URS Corporation 12120 Shamrock Plaza, Suite 300 Omaha, NE 68154	Project Name: FWDA Work Plan and Removal
	Project Location: Fort Wingate, Gallup, NM
	NCR No.: 001
Project No.: 16170613	MRS: CAMU Grid: N/A
Contract#: W912QR-04-D-0025	Date: 9/11/2013

NONCONFORMANCE AND CORRECTIVE ACTION REPORT

URS CORPORATION FIELD CHANGE REQUEST (FCR)

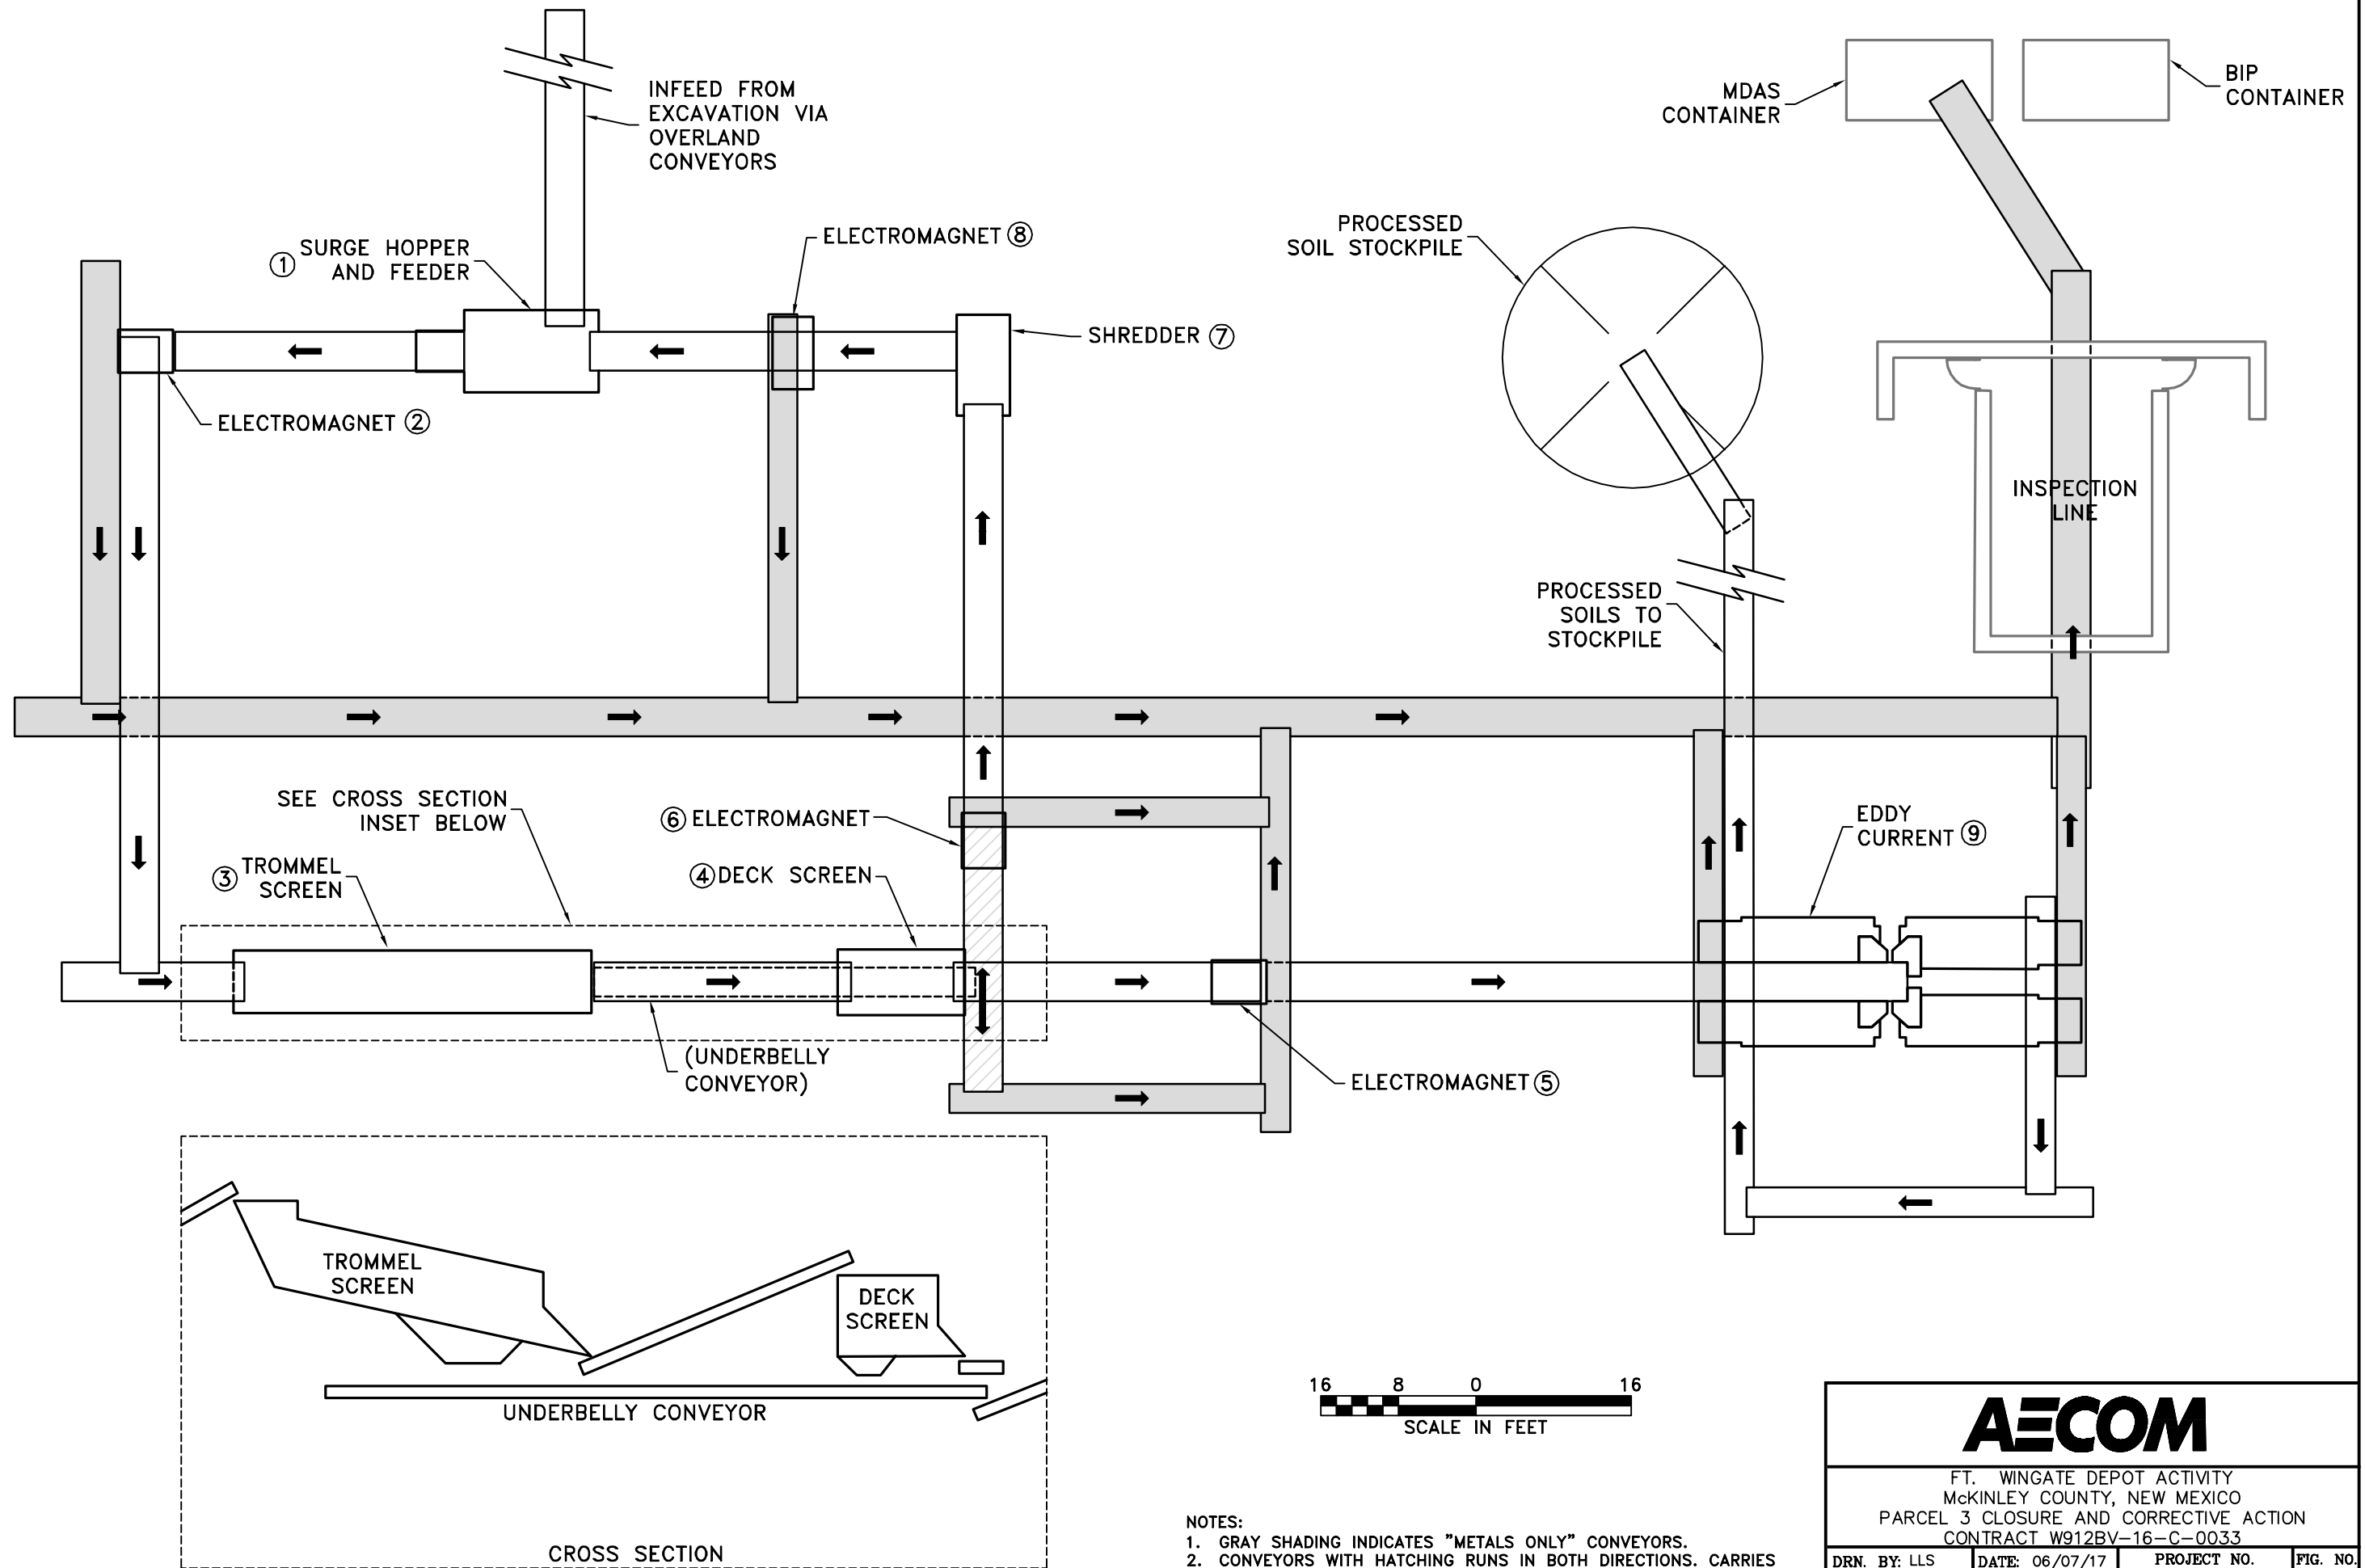
1. DESCRIPTION (items involved, submit sketch, if applicable): Revised figure and text to describe the HWMU processing plant layout and equipment. See attached plant layout schematic and supporting text describing the plant processes.

Point of excavation. Soils are excavated utilizing remote controlled heavy equipment. Excavated materials are fed onto a grizzly feeder with 6-inch bar spacing, allowing only material smaller than 6-inches to be fed to the processing plant. The material exiting the grizzly feeder is transferred to the processing plant via a series of overland conveyors. The conveyors can be moved and conveyors can be added or removed as the excavation location changes.

The oversize material larger than 6-inches that does not pass through the grizzly feeder will be stockpiled near the excavation area. Periodically the oversize material will be inspected for MEC by qualified UXO technicians and then run through a jaw crusher to reduce the oversize material to less than 6-inches. Once the material has been reduced in size, it will be fed into the grizzly feeder as part of the routine excavation process.

- (1) Surge hopper and feeder:** Infeed from the excavation is deposited into the surge hopper and feeder. The surge hopper allows the feed rate to the plant to be metered. Material is fed onto a conveyor toward an electromagnet (2).

- (2) Electromagnet:** Material passes beneath an electromagnet. Ferrous items are removed and deposited onto a “metals only” conveyor (shaded in gray on the attached figure) and transported to the Inspection Line to undergo MPPEH inspection. Remaining material is deposited onto a conveyor to the trommel screen (3).
